STANDARDIZATION OF COMPONENTS
FOR
CD V-700, CD V-715, CD V-727

BY
THE VICTOREEN INSTRUMENT COMPANY
CLEVELAND, OHIO

III. Recommended Specification Changes

A. Changes in CD V-700 Specification dated November 1, 1959.

Figure 16

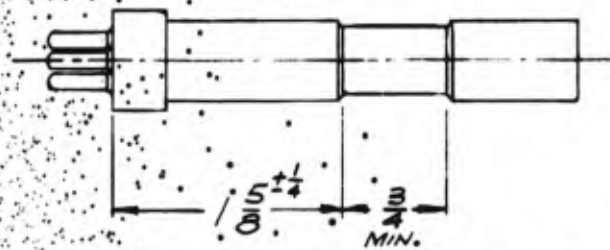
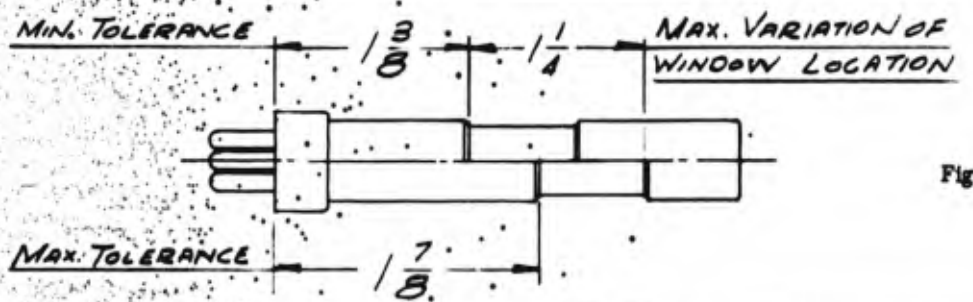
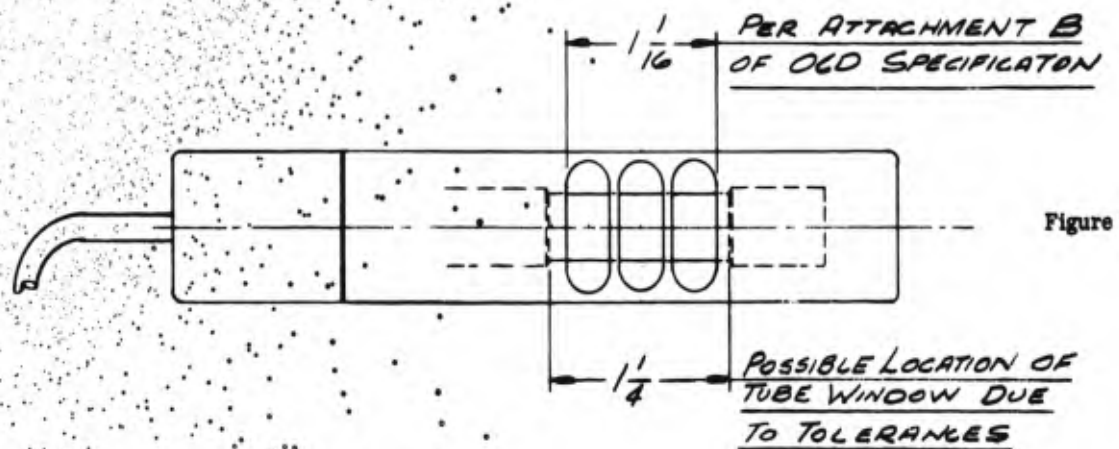
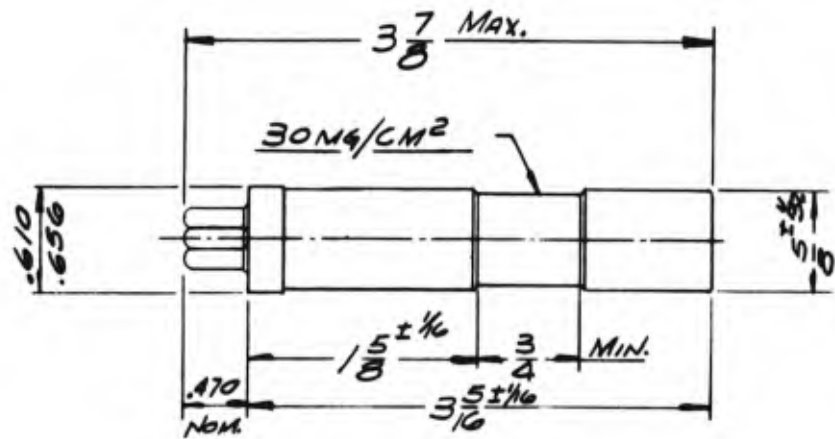
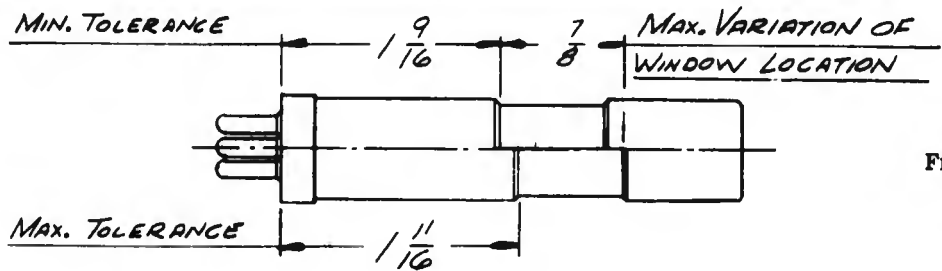
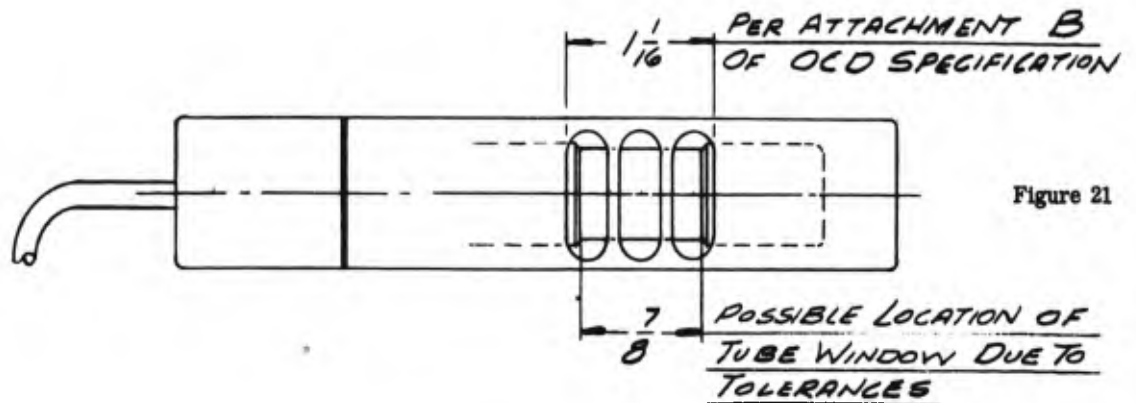
11. Page A-6. Revise drawing dimensions as follows: Change the $\pm 1/4$ tolerance on the $1-5/8$ dimension to $\pm 1/16$. Change the tube diameter dimension to $5/8 \pm 1/32$.

The geiger tube probe drawings, Figures 9 thru 13, along with the changes of tolerance on the window location of the geiger tube makes for a uniform assembly in which the geiger tube window and the probe window will always line up properly. Figures 16 thru 21 show the complete developmental story. Figure 16 is the present specified geiger tube. Figure 17 shows the variations in window position possible. Figure 18 shows the result on the combination of probe and tube as presently specified and found in the prototypes. Figures

19, 20 and 21 show the same items with the new proposed dimensions and tolerances.

Figure 22. Type 6993 Revised Test Procedure

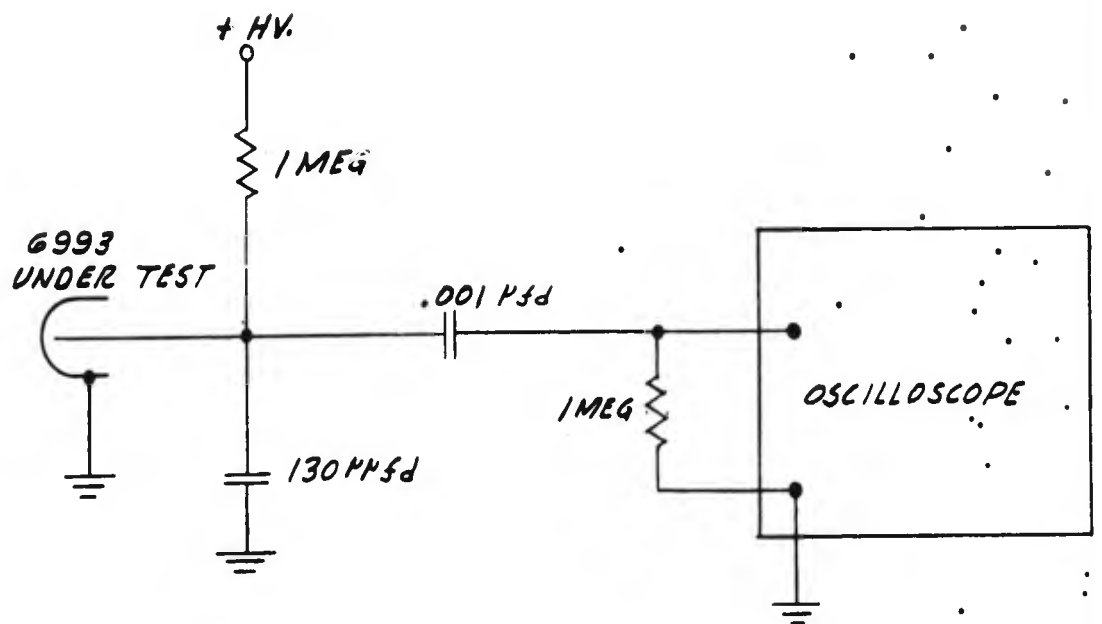
One additional specification modification on the geiger tube, which perhaps should be included but is not really mandatory, is a revision of the geiger tube test procedure. The circuit of Figure 22, is a suggested test circuit which can evaluate the geiger tube performance as related to the modern semiconductor circuits in which it is now used. The input impedance of these circuits is materially different from that of the older tube circuits for which the present tests were set up. With this test circuit the pulse output with a high voltage of 860 volts should not be less than 0.25 volts and the pulse width should not exceed 150 microseconds at 63% down from the pulse peak. These pulse heights and widths refer to the geiger tube only and have no bearing on the signal at the headphone connector. It is not recommended that the signal output for the headphone be changed.
